UNITED STATES PATENT AND TRADEMARK OFFICE

APPLICATION NO.	FILING DATE	FIRST NAMED INVENTOR	ATTORNEY DOCKET NO.	CONFIRMATION NO.
09/677,870	10/03/2000	Woo Hyuk Choi	2658-0240P	6124

Office Action Summary

DETAILED ACTION

FIG. 6

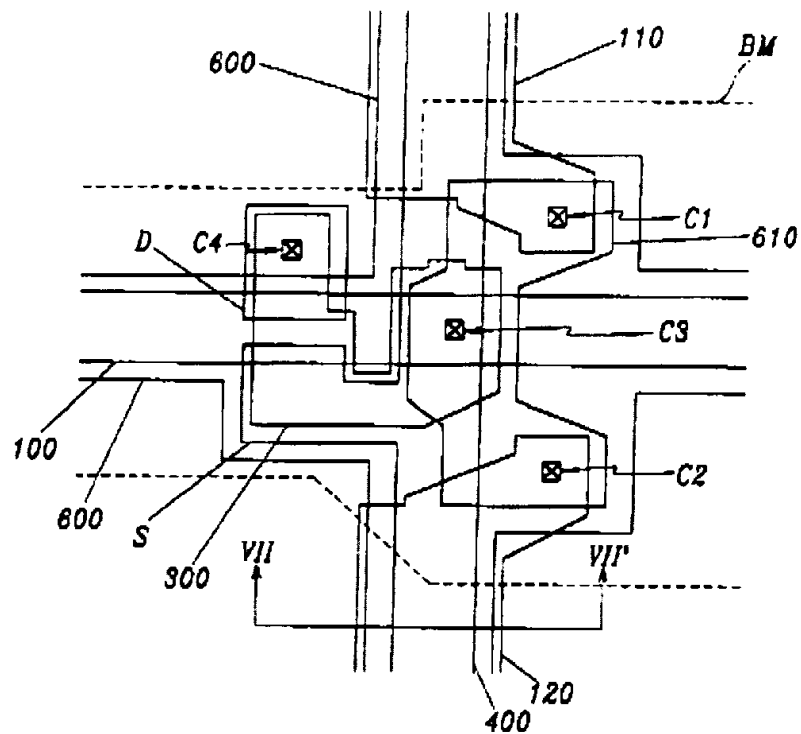
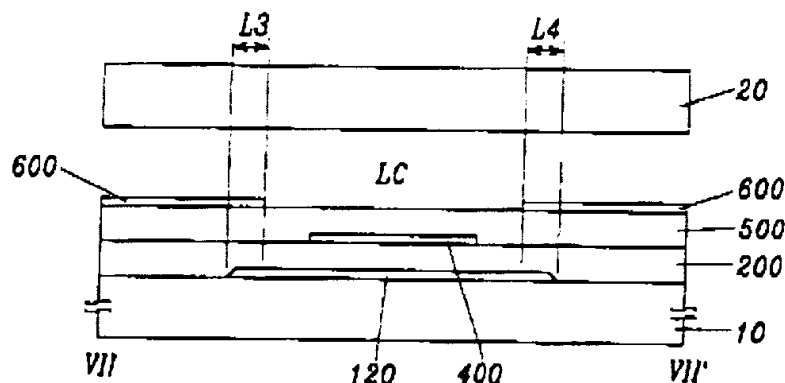
As to claims 1 and 2, Kim discloses in the third embodiment, Figures 6 and 7, (col. 6, line 35 through col. 7, line 5), a thin film transistor substrate in a liquid crystal display provided with a data lines, 400, for applying a data signals, a gate line, 100, for applying a gate signal, and a transparent pixel electrode, 600, for driving a liquid crystal cell, said substrate comprising: repair lines, 110 and 120, (Applicant's gate dummy pattern) formed of the same material layer as the gate line (col. 6, lines 38-42 and col. 2, lines 10-17) in such a manner to be extended in the vertical direction from the gate line, 100, and to overlap the pixel electrode, 600, and data line 400, to compensate for misalignment occurring along the data line.

FIG. 13

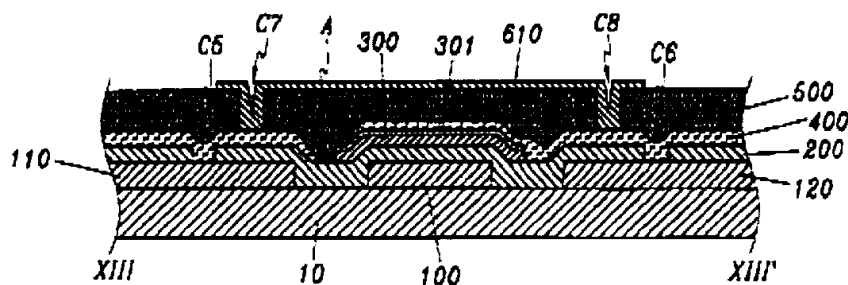
Kim teaches in Figure 13 the use of forming holes and connections to the repair lines, 110 and 120, (Applicant's gate dummy pattern) and to a connecting pattern, 610, to repair a broken data line, 400, (col. 8, lines 1-15).

FIG. 26

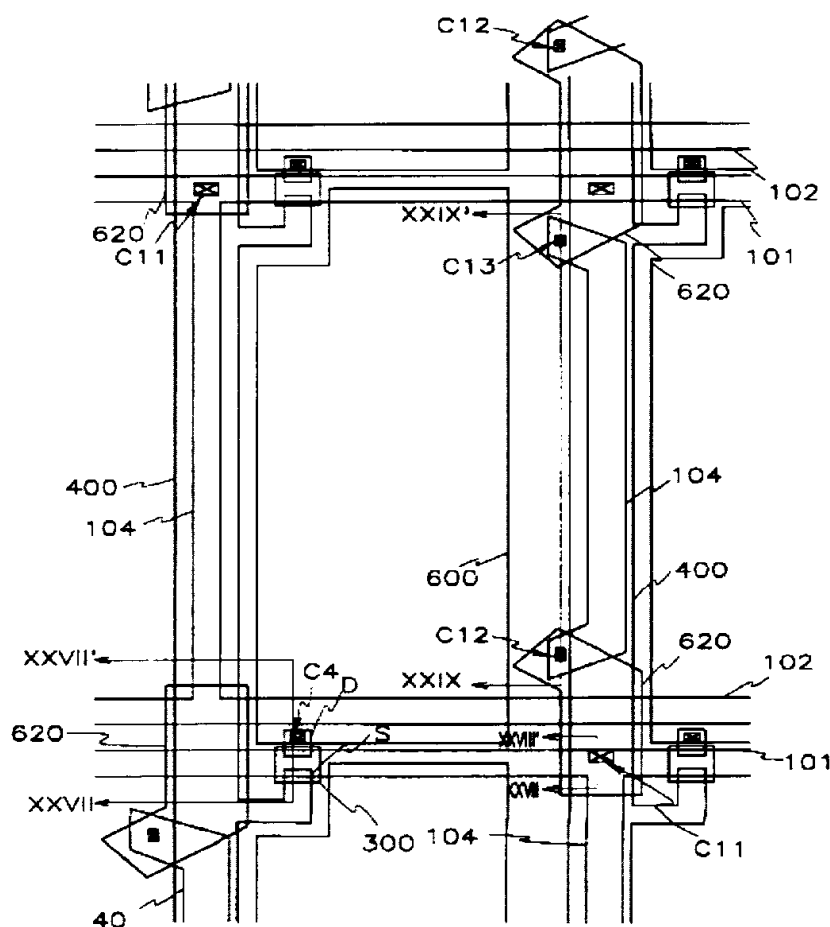
Kim teaches in Figure 26 the use of repair lines, 104, (Applicant's gate dummy pattern used as a redundancy electrode) to connect the gate line to the data line (col. 13, lines 4-17).

FIG. 19A

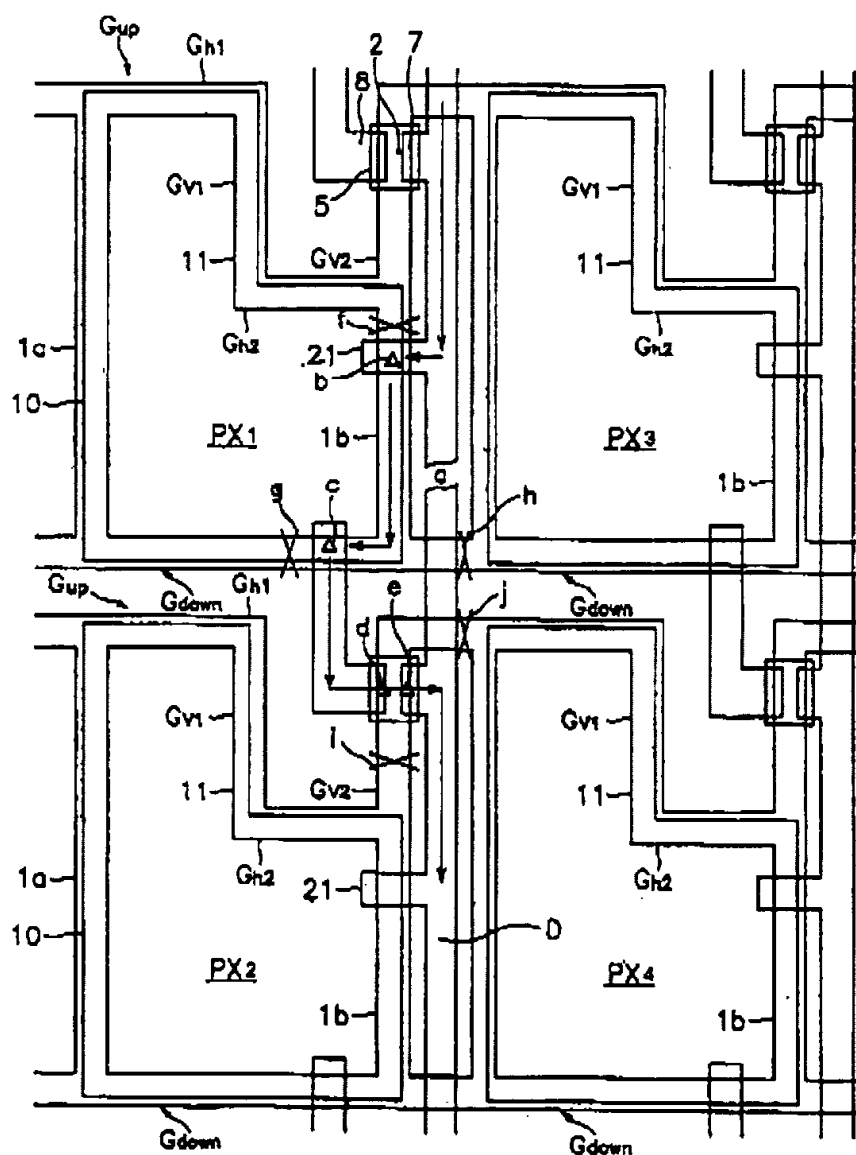
Song teaches the use of a redundant pattern in Figure 19A (G_{up} and G_{down} or 1a and 1b) as a redundancy electrode for electrically connecting the gate line to the broken data line (col. 17, lines 4-67, especially col. 17, lines 47-54) to effect repairs.

As to claim 4, Song teaches in Figures 16-27D, e.g., Figure 19A, (col. 12, line 51 through col. 25, line 45) and throughout much of the text, a substrate wherein the left and right auxiliary gate lines (Applicant's gate dummy pattern) includes a disconnect, e,

(Applicant's hole) (col. 17, lines 4-67, especially col. 17, lines 47-54) connected to the gate line and formed to permit a repair.

FIG. 18

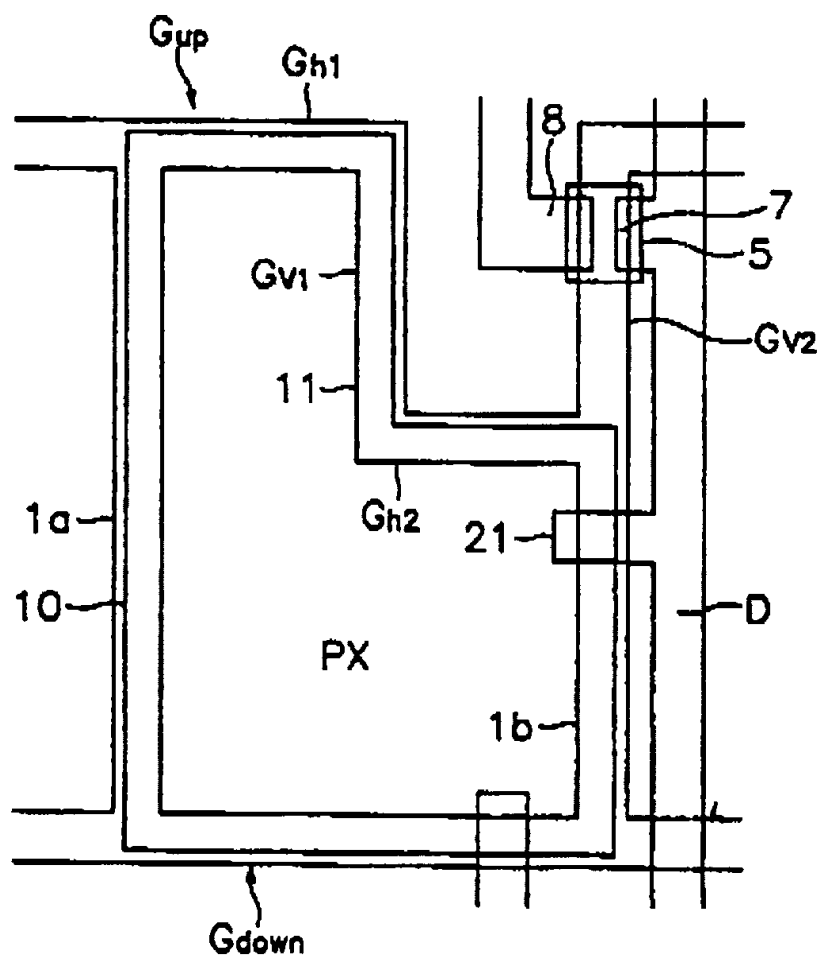
As to claim 6, Song teaches in Figure 18 a thin film transistor substrate further comprising: a storage capacitor defined by a horizontal overlapping part, G_{h2} , between the gate line and the pixel electrode, PX. Song also teaches in Figure 18 an analogous overlapping portion, 21, of the data line, D, to permit a repair.

As to claim 7, Song teaches in Figures 18 and 19A a protrusion, 21, formed in such a manner to overlap with the hole (to be created during repair), the structure of which would thereby shut off a light leaked between the gate dummy pattern and the gate line (col. 15, lines 42-63).
